BABCNC PLU LIST OF QUESTIONS

Motion for Applicant/Owner to return to the BABCNC PLU committee with answers to the following questions from our July PLU (2261 BOWMONT Drive 90210 DIR-2021-9948-DRB-SPP-MSP) are:

PREVAILING SETBACK SURVEY

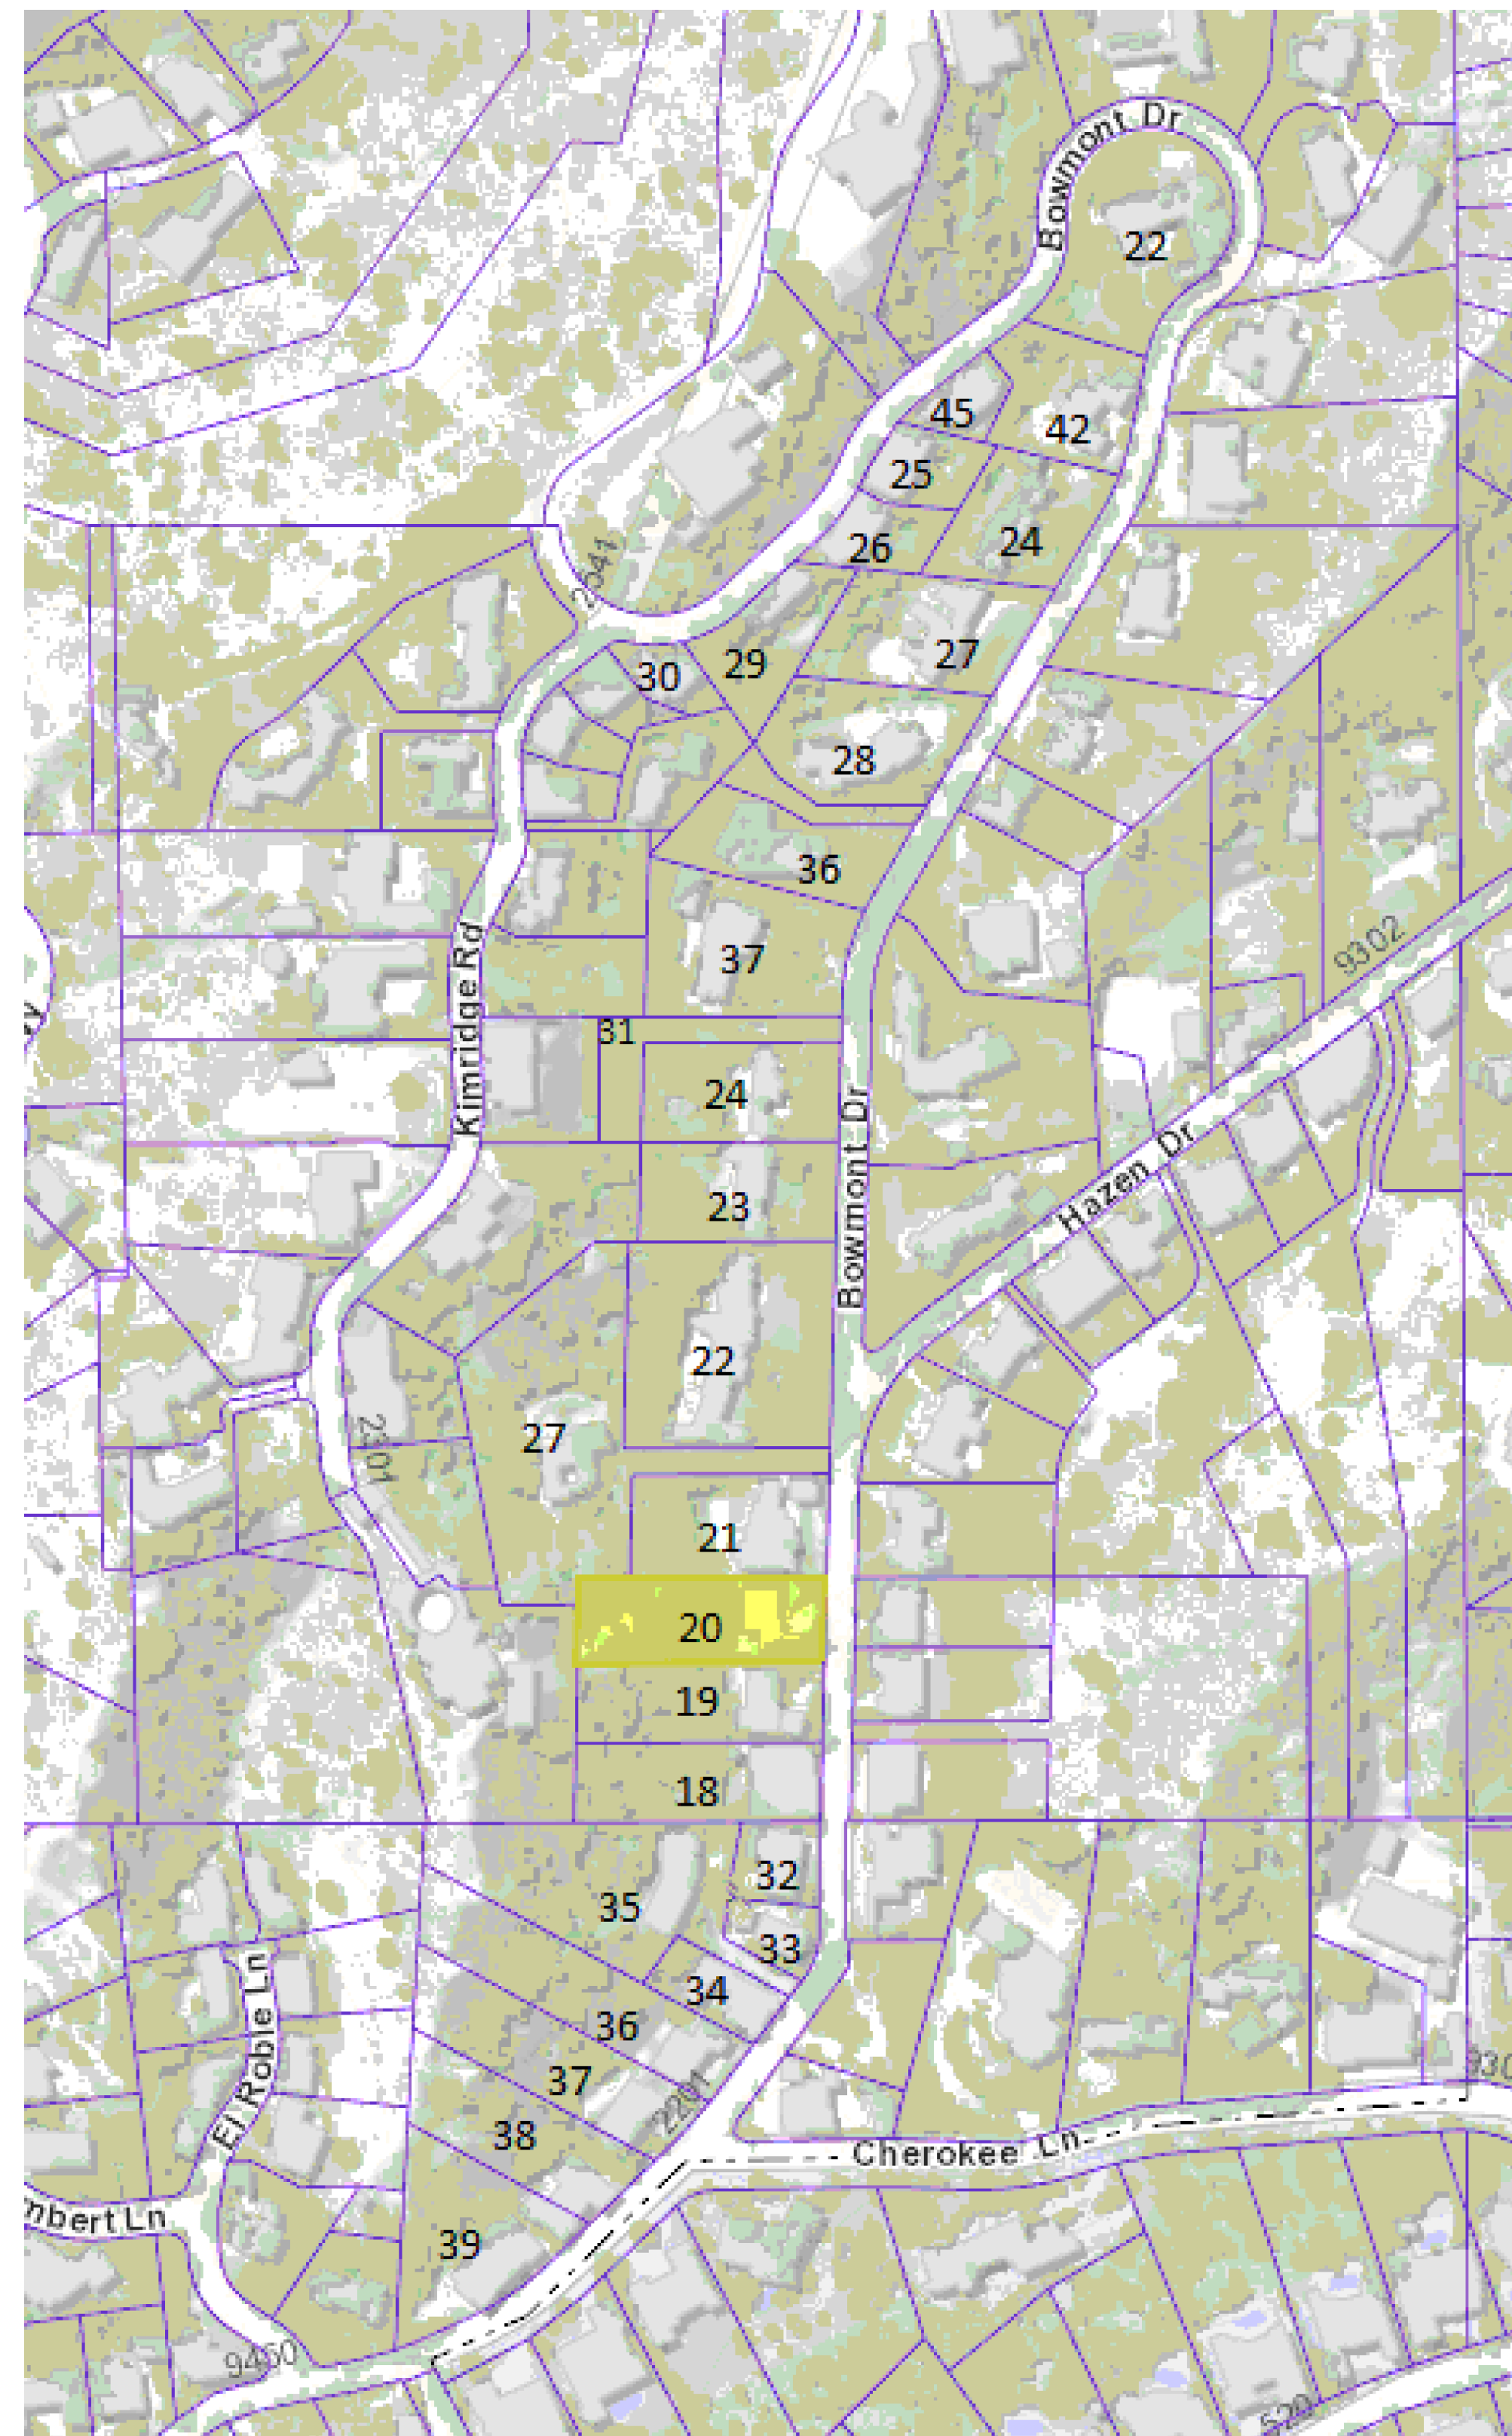
6. Drawings show fence in the front yard setback to be 6', however an entitlement is needed if gate, fence or wall exceeds 3.5' in height. The Lot is an RE-15 lot with a required FYSB of 20' (if applicant is using prevailing no calculations were included in application. And google earth show most FYSB's from street to street exceed 5'. An average FYSB of 5' would not occur, verify!

The proposed fence is beyond the required prevailing front setback of 5'. Therefore the 3.5' height limit is not applicable to it. The addition under DRB review has a 23' setback from the front property line. All information has been verified. See LA Zoning Code for how to calculate the prevailing setback and the attached Prevailing Setback Survey. Building and Safety enforces the fence height regulations.
